Technical Service Bulletin (TSB) Diesel Exhaust Fluid (DEF) Fluid Freezing

REFERENCE:	TSB: 14-003-23 GROUP 14 - Fuel System	Date:	April 15, 2023	REVISION:	-
VEHICLES AFFECTED:	2019 - 2022 (DJ) RAM 2500 Pickup 2019 - 2022 (D2) RAM 3500 Pickup 2019 - 2022 (DD) RAM 3500 Cab Chassis 2019 - 2022 (DP) RAM 4500/5500 Cab Chassis This bulletin applies to vehicles equipped with the 6.7L I6 Cummins Turbo Diesel engine (Sales Codes ETL and ETN) or the 6.7L I6 Cummins HO Turbo Diesel engine (Sales Code ETM).			MARKET APPLICABILITY: ☒ NA ☐ SA ☐ EE ☐ MEA ☐ IAP ☐ CH	
CUSTOMER SYMPTOM:	Customers may experience a Malfunction Indicator Lamp (MIL) illumination. Upon further investigation the technician may find the following Diagnostic Trouble Code (DTC) has been set: P203E-00 - Reductant Level Sensor 1 Circuit Intermittent-Erratic.				
CAUSE:	- Repeated freeze/thaw cycles of the urea tank to cause solid DEF crystals to form and settle on the focus tube, blocking the level sensor signal. - Rapid temperature swings from below freezing to above freezing causing an incomplete thaw of the DEF tank. When the vehicle is powered on, the diagnostic is enabled due to thawed DEF at the tank bottom surface, but

Fig. 1
DEF Tank Assembly

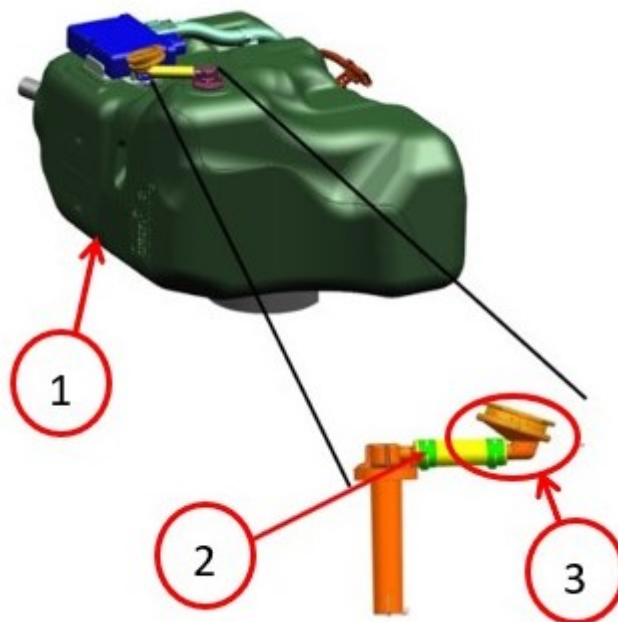
1. Remove the DEF tank. Refer to the detailed service procedures available in DealerCONNECT> Service Library under: Service Info> 25 - Emissions Control / Diesel Exhaust Fluid Emissions / Tank, Diesel Exhaust Fluid / Removal (Fig. 1) .

2. Loosen the hose clamp on the GVV hose and remove the GVV from the DEF tank.
3. Remove and replace the DEF Tank Grade Vent Valve with the new GVV (Fig. 2) .

This bulletin involves replacing the urea delivery module and grade vent valve and updating the Dosing Control Unit (DCU) software.
